Designed by	Checked by	Date	Project No:	Rev:
Karol	S.J.Lyons	21/06/2016	1157	11

1157.Royal College of Music-LayOut

3D Site Layout

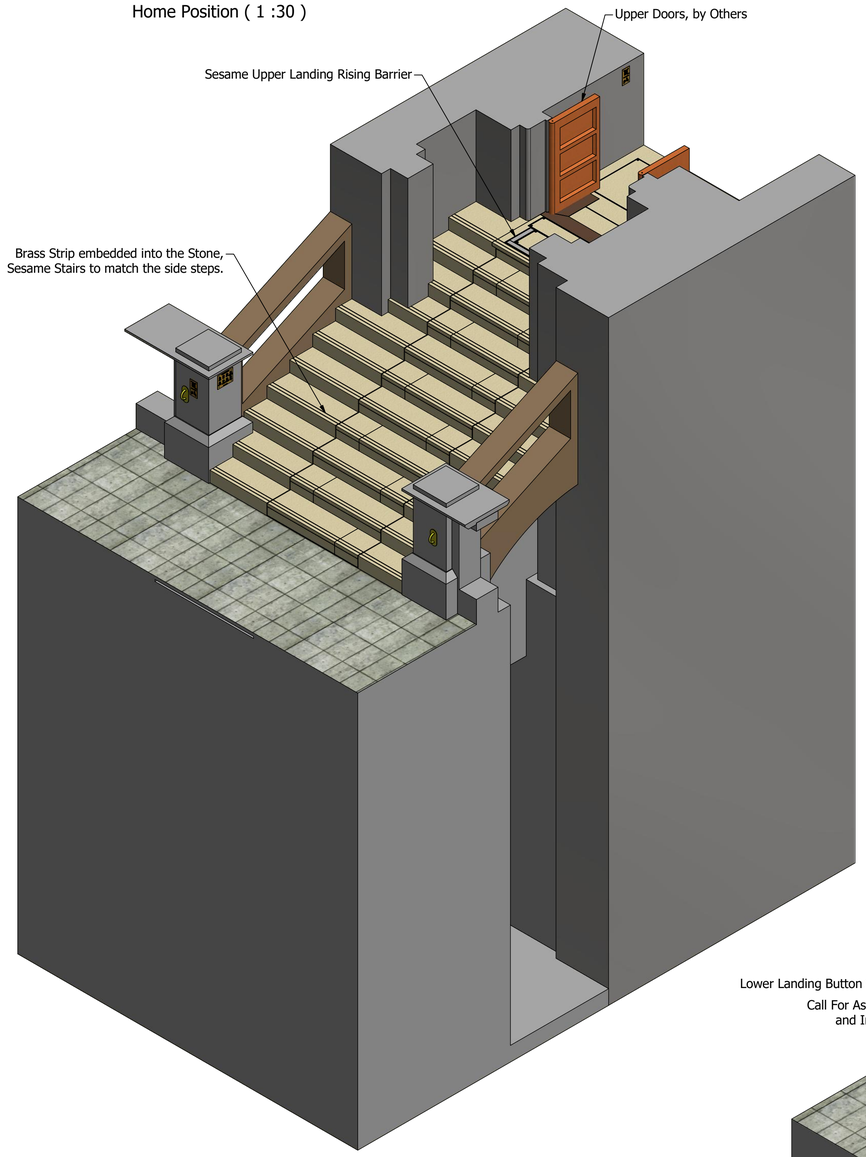
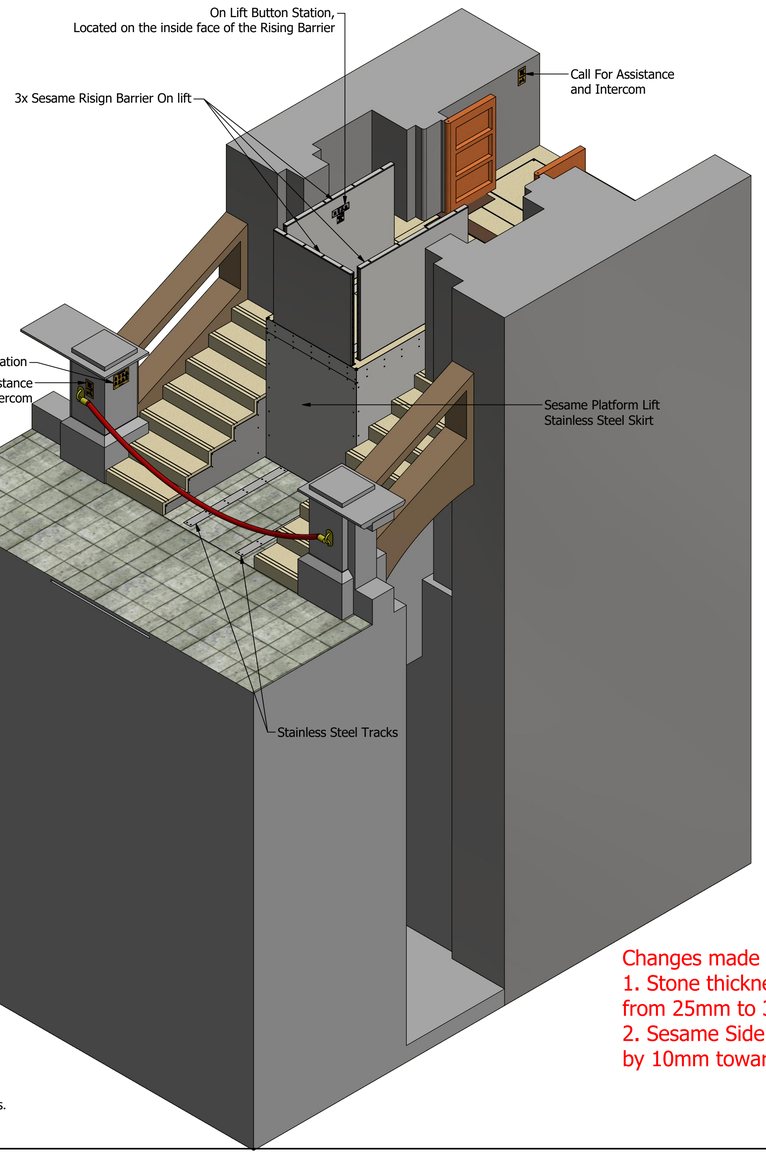
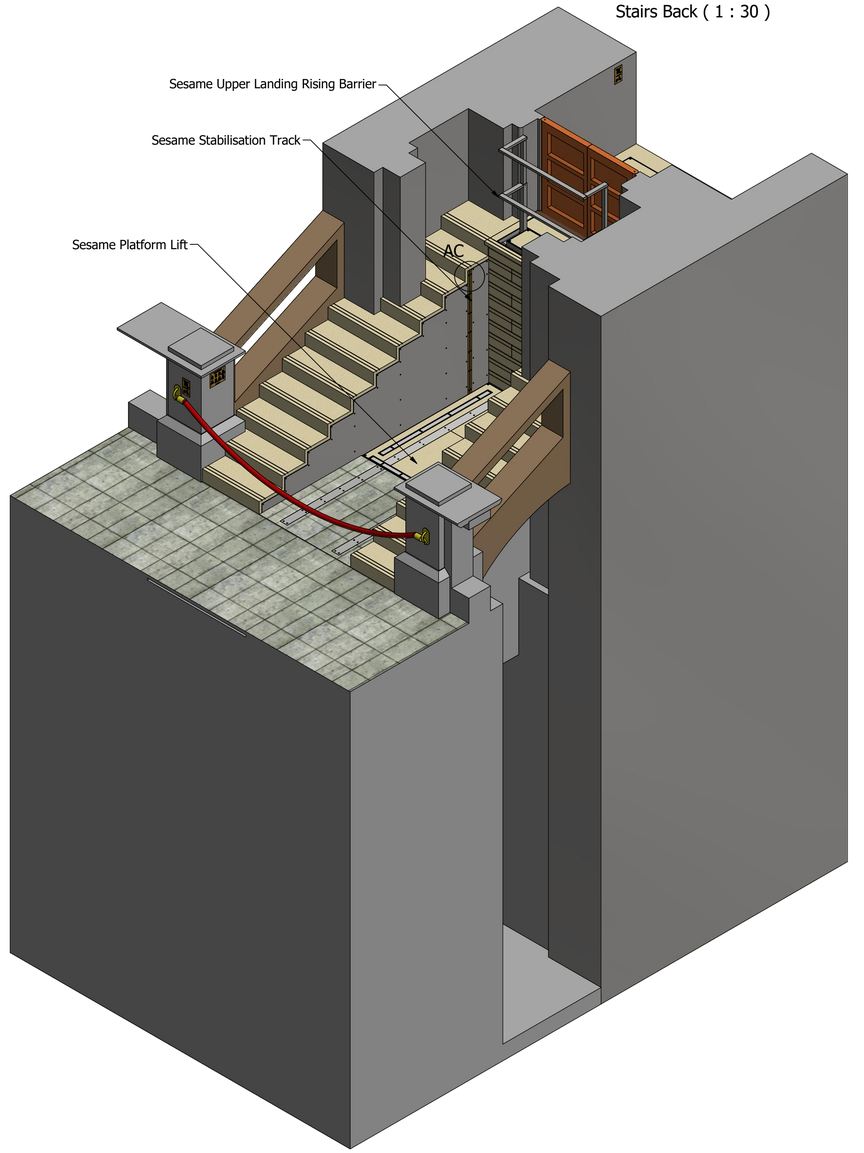
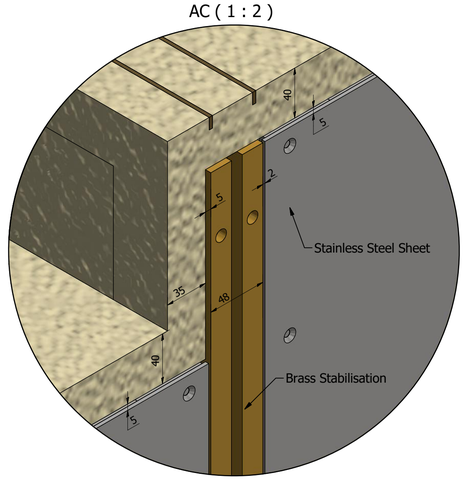
Changes made since last revision:
1. Stone thickness on steps risers has been changed from 25mm to 35mm,
2. Sesame Side stainless steel panels has been moved by 10mm toward the upper lading doors.
